**UNITED STATES AIR FORCE  
ELMENDORF AIR FORCE BASE,  
ALASKA**

**EXPLANATION OF SIGNIFICANT DIFFERENCES  
OPERABLE UNIT 6**

**FINAL**

**MARCH 2007**

**FIGURE 3.1**  
**CUMULATIVE MASS REMOVED (SD15)**  
**OU 6 EXPLANATION OF SIGNIFICANT DIFFERENCES**  
**ELMENDORF AFB, ALASKA**

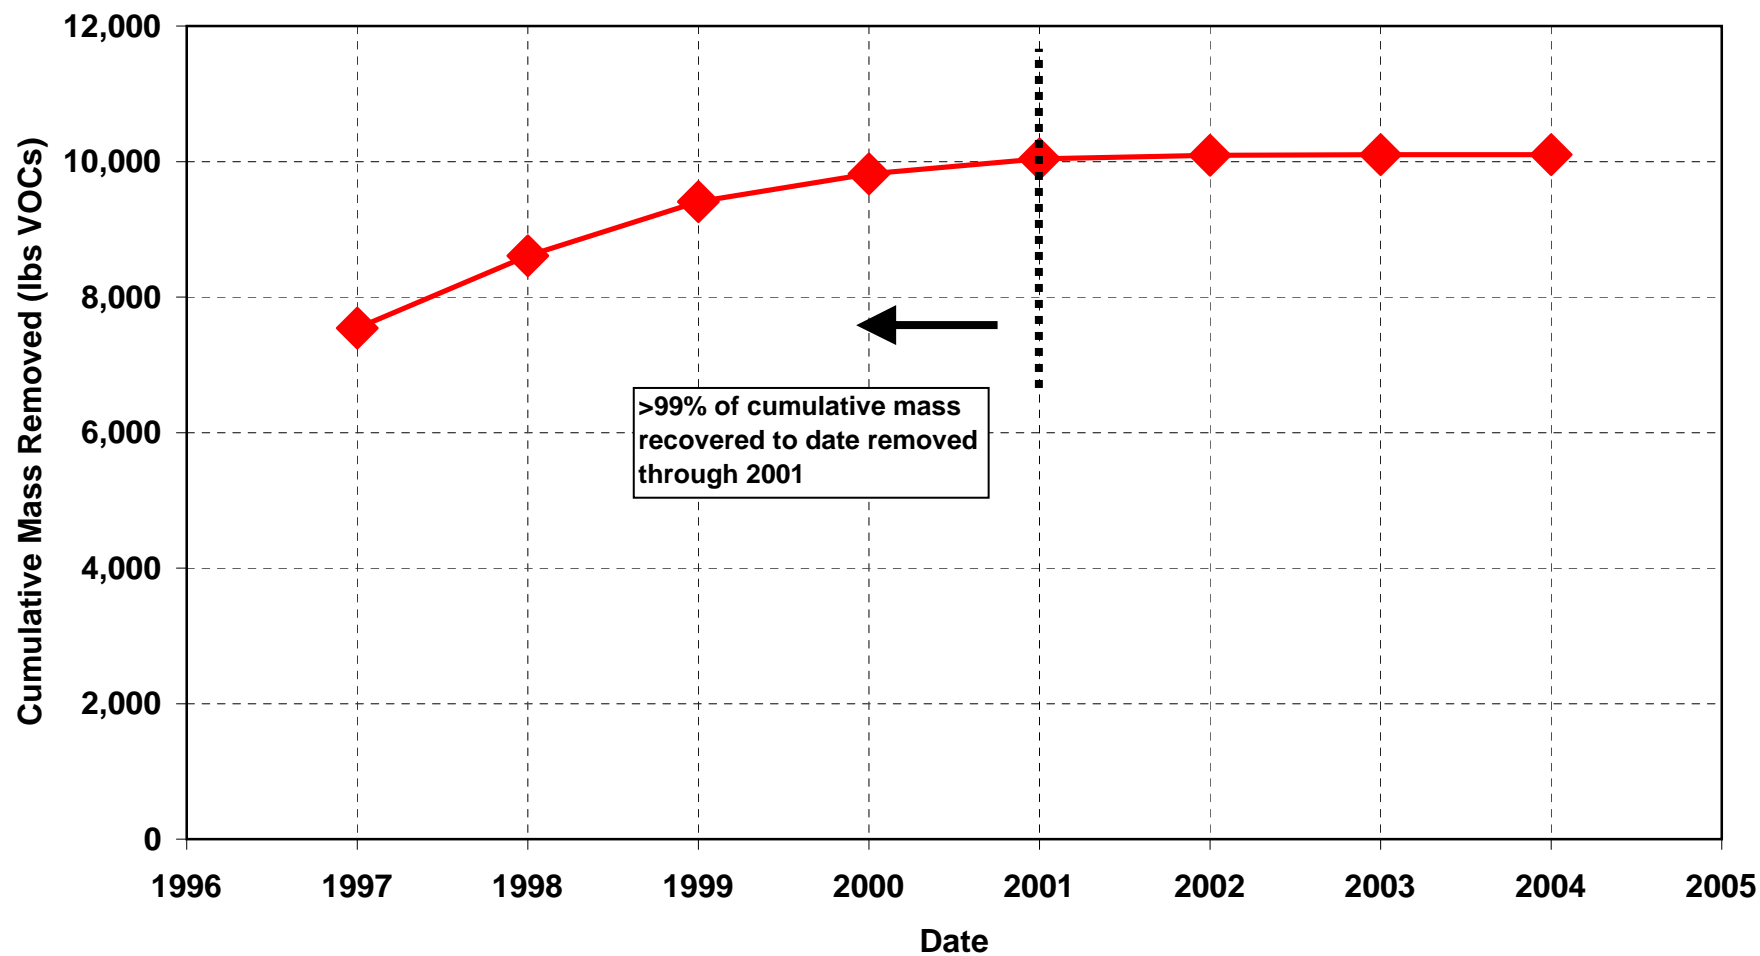
Operation of the HVE system at SD15 has been ongoing since 1996. During the past nine years, over 10,000 lbs of contaminant mass has been removed. However, over 99 percent of that mass was removed during the first four years of operation as illustrated in Figure 3.1. Since 2001, only 60 lbs of contaminant mass has been recovered, while costs to operate and maintain the system has remained relatively constant.

As stated in the *2004 Annual Technical Report - Environmental Monitoring and System Optimization of SD15 High Vacuum Extraction System* (Elmendorf AFB, 2005), mass recovery has steadily declined to a point where the HVE system has reached its technological limit and is no longer effective at removing contaminants (Elmendorf AFB, 2005). These conclusions were supported by the USEPA in correspondence dated 23 March 2005 (USEPA, 2005) and ADEC in correspondence dated 2 March 2005 (ADEC, 2005).

Based on the data presented in Section 3.1, HVE system operations can be terminated at this time. Monitoring the contaminant plume and natural attenuation parameters, which has been ongoing during HVE operations, will continue until the groundwater cleanup goals are reached. Details regarding MNA’s potential at SD15 and plan for implementation are provided in Appendix B. The information in Appendix B summarizes and evaluates monitoring data collected to date, and outlines a MNA implementation strategy. The implementation strategy includes a contingency plan should MNA not meet the cleanup goals. Performance of MNA at SD15 will be evaluated by collecting groundwater samples for VOCs on an annual basis. As this new data becomes available, trend analysis will be performed on Benzene and TCE to evaluate progress toward meeting the cleanup objective and the need to implement contingencies.

**Figure 4.4**  
**LF02 LAND USE CONTROL**  
**BOUNDARIES FOR SOIL**  
**AND GROUNDWATER**

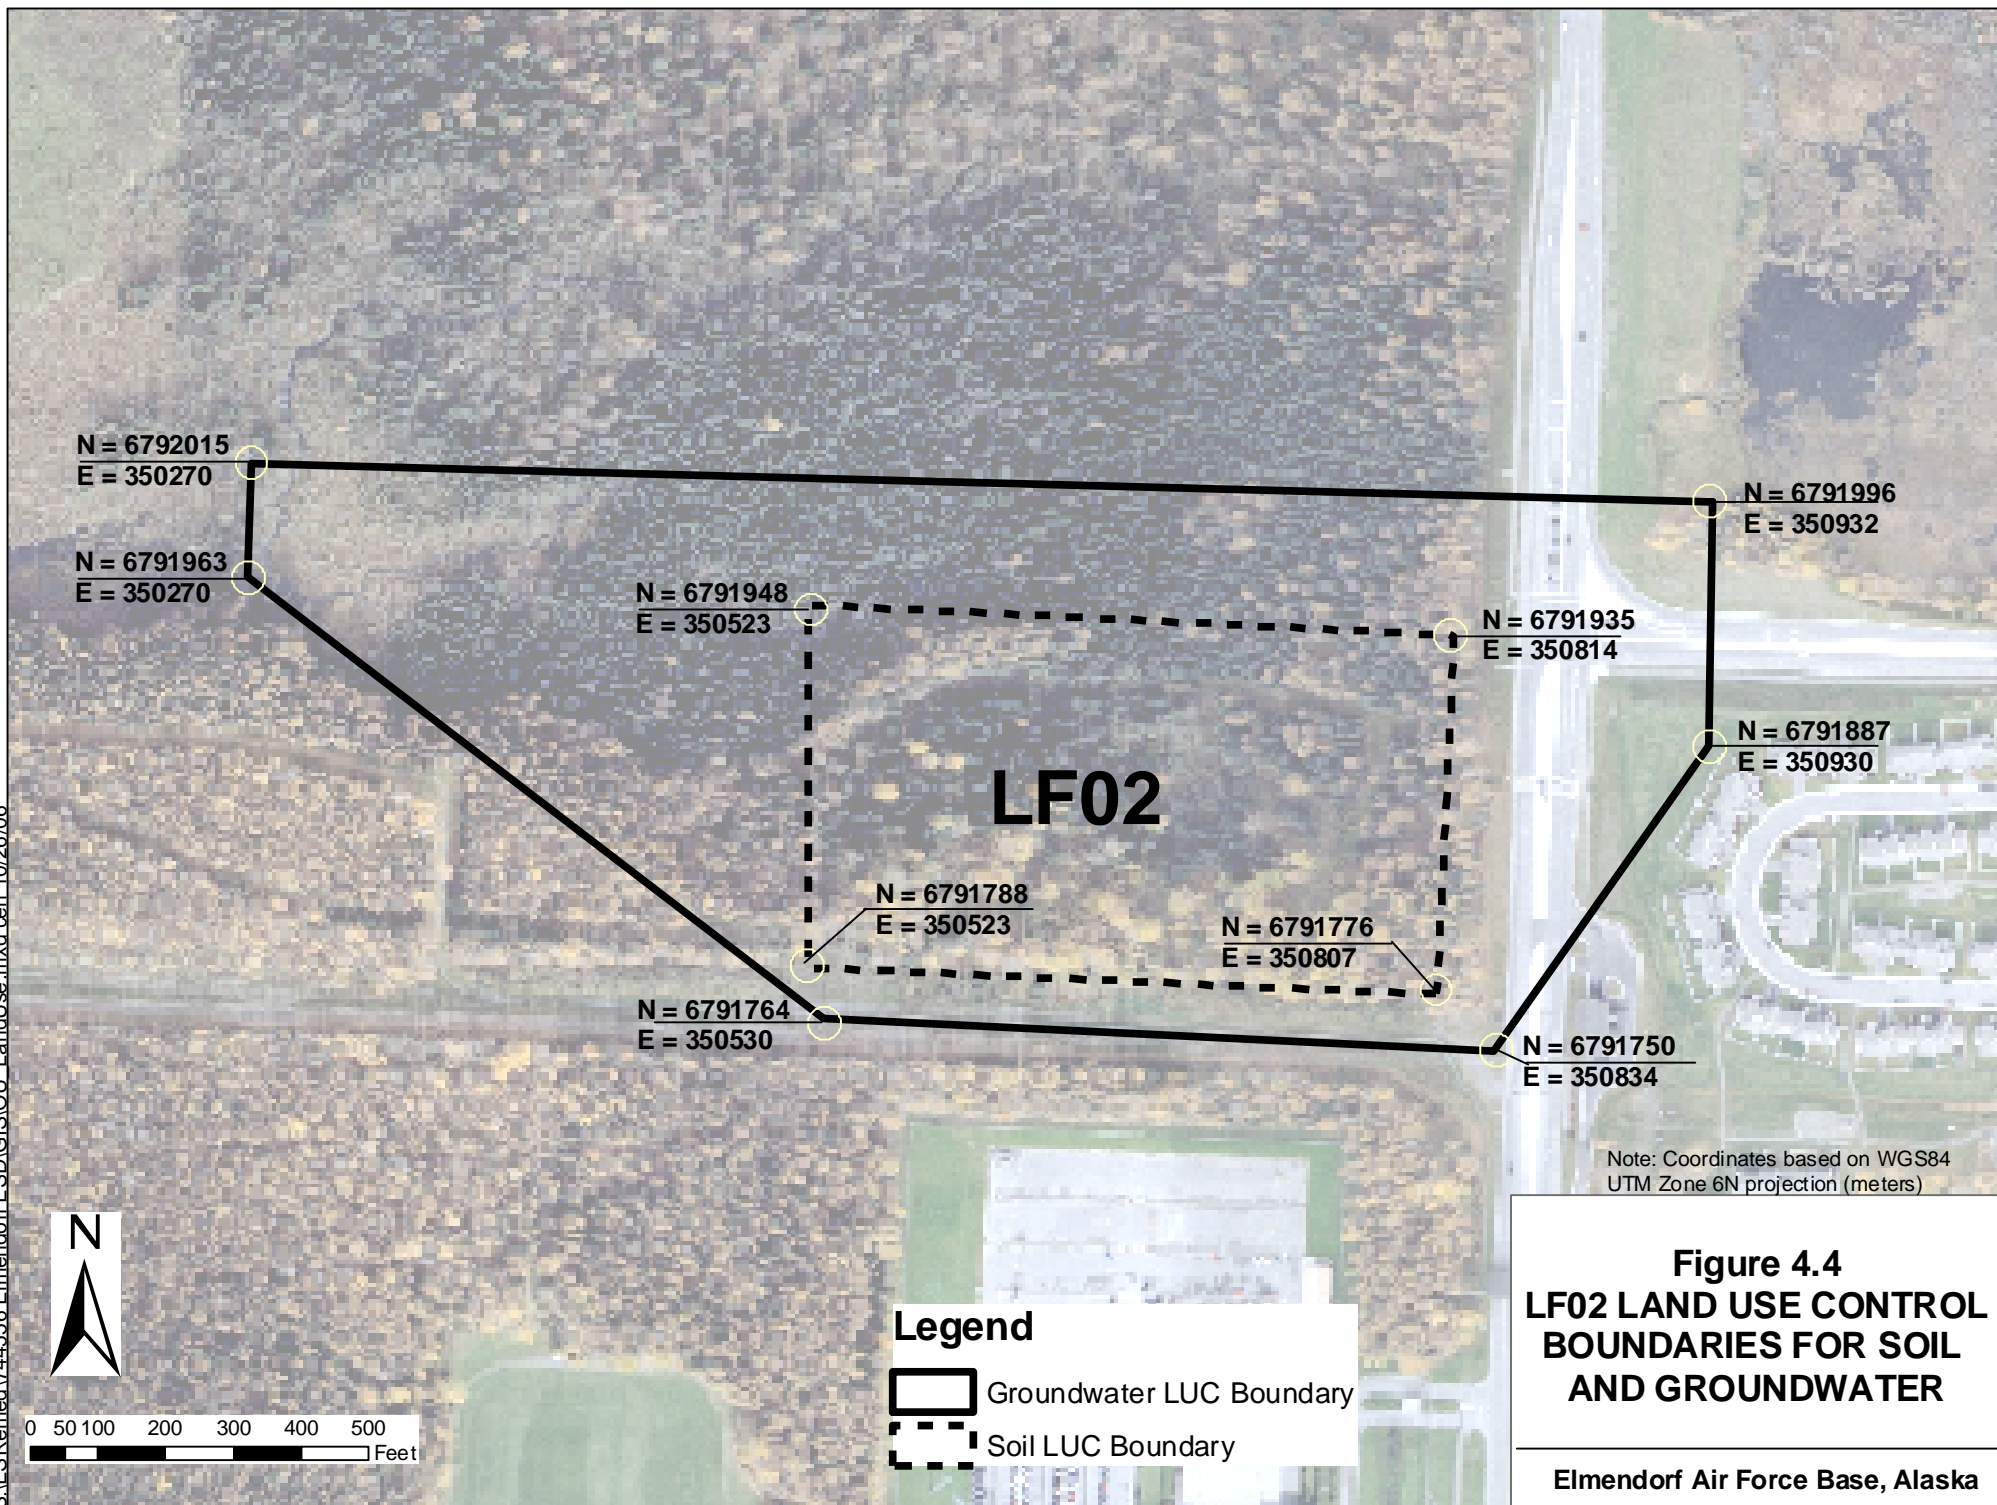
- Source Area LF02 – groundwater. Access to soil at LF02 will be institutionally controlled. LF02 is currently designated as a "restricted use area" in the Base General Plan. This designation provides for recreational use of the parcel (e.g., cross country skiing) and for construction of unmanned facilities such as a parking lot, storage building, or taxiway, but prohibits the construction of any sort of manned facility such as an office building or a residence. Drilling into the shallow aquifer is also restricted by the Base General Plan to prohibit residential or agricultural use of contaminated groundwater.

- Source Area LF02 – soil. Access to soil at LF02 will be institutionally controlled. LF02 is currently designated as a "restricted use area" in the Base General Plan. This designation provides for recreational use of the parcel (e.g., cross country skiing) and for construction of unmanned facilities such as a parking lot, storage building, or taxiway, but prohibits the construction of any sort of manned facility such as an office building or a residence. Drilling into the shallow aquifer is also restricted by the Base General Plan to prohibit residential or agricultural use of contaminated groundwater.

- For Source Areas WP14 and LF04 South Land Use Control Boundaries for Groundwater - Figure 4.1
- Source Area LF04 North Land Use Control Boundaries for soil - Figure 4.2
- Source Area SD15 Land Use Control Boundaries for groundwater - Figure 4.3
- Source Area LF02 Land Use Control Boundaries for groundwater and soil - Figure 4.4
- Source Area LF03 Land Use Control Boundaries for groundwater and soil - Figure 4.5
